## GRSG 118<sup>th</sup> session

### UN Regulation No. 93 *OICA comments to proposal*

[ECE/TRANS/WP.29/GRSG/2020/10](#) (EC)

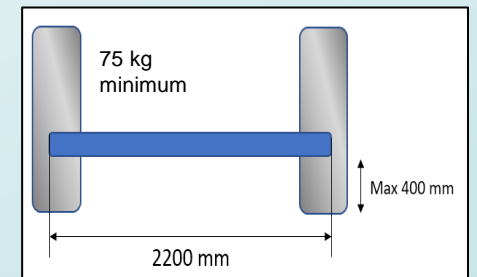
- A moveable FUP (currently not existing) would require specific protections to guarantee its function integrity:
  - Dirt environment damages to the mechanism in case of a moveable FUP.
  - Protection of deployment mechanisms
  - A foldable or partly foldable FUP could make the vehicle longer
  - Impact on the masses and dimensions and packaging

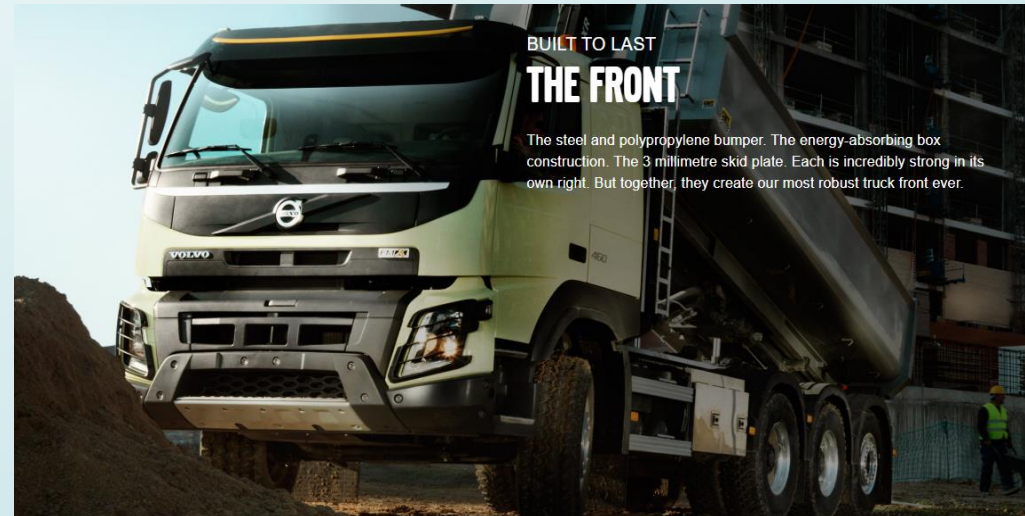
- A FUP on a category G vehicles may have to withstand forces higher than those of UN R93 test forces to secure the daily operation
